# Service Bulletin

**SUBJECT:** Service Update for Inventory and Customer Vehicles  
Turbo-to-Exhaust Manifold Joint May Relax  
Expires with Base Warranty

**MODELS:** 2013 Cadillac ATS  
2013 Chevrolet Malibu  
Equipped with 2.0L Engine (LTG)

3268362

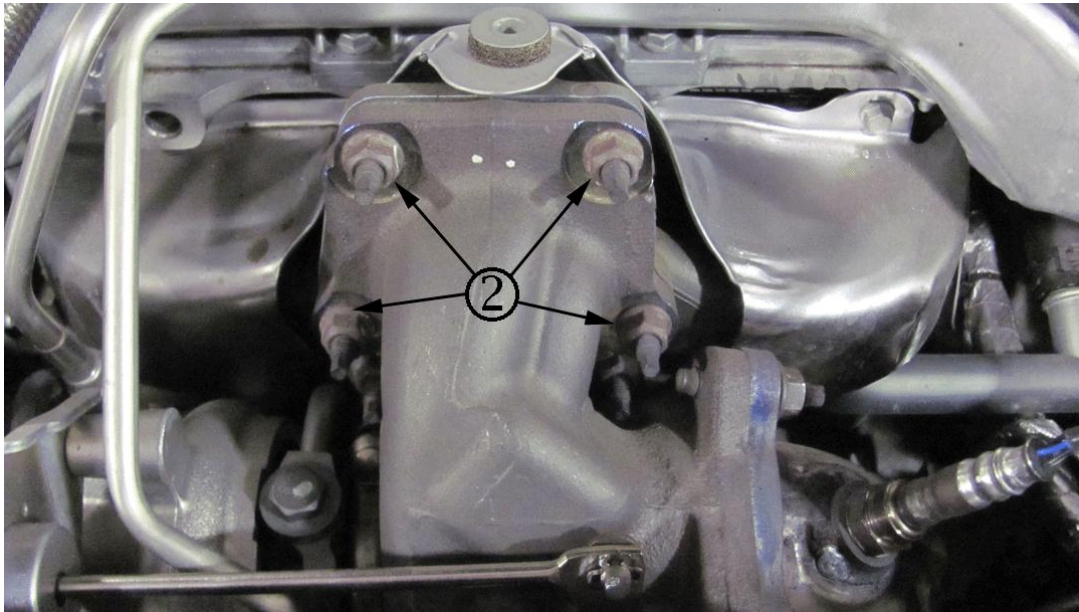
2. Locate the turbocharger exhaust heat shield (1).

3. Remove the turbocharger exhaust heat shield. Refer to *Exhaust Manifold Heat Shield Replacement (LTG)* in SI.

4. Tighten the four turbocharger-to-exhaust manifold nuts (2) to **30 Nm (22 lb-ft) + 90 degrees**.
5. Re-install the turbocharger exhaust heat shield. Refer to *Exhaust Manifold Heat Shield Replacement (LTG)* in SI.
6. Tighten turbocharger exhaust manifold heat shield fasteners to **9 Nm (80 lb-in)**.
7. Close the hood of the vehicle.
